Access Compliance Report

Public Rights-of-Way

| Intersection ID: 28868 | Main Street: BIRDWELL_CT | Cross Street: SUTTONVIEW_DR | Location: S |
| ADA ID: ECDE48D5E658 | Ramp Type: PerpDiag | Initial Pass/Fail: Fail | Overall Compliance: No |

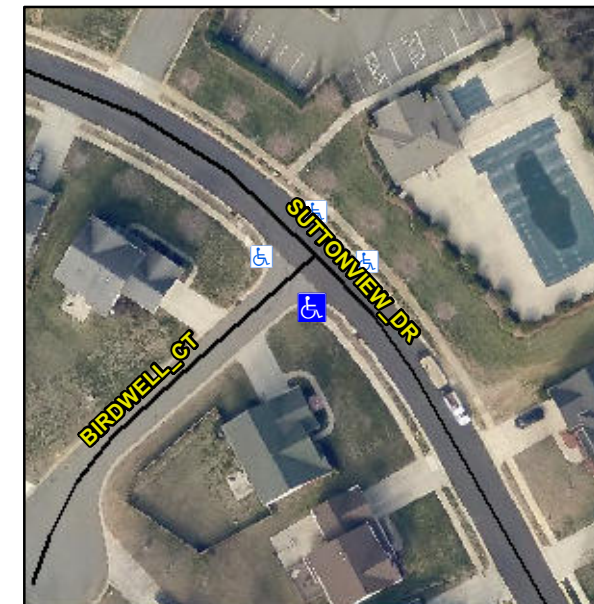
Not Found, R304.5.1

| Compliance | Description | Data | Compliance | Description | Data |
|------------|-----------------------|-------|------------|-----------------------------|-------|
| No | Ramp Width (in) | 39.0 | Yes | Ramp XSlope (%) | 1.9 |

Remove & Replace Curb Ramp With Two New Directional Ramps or Equivalent.
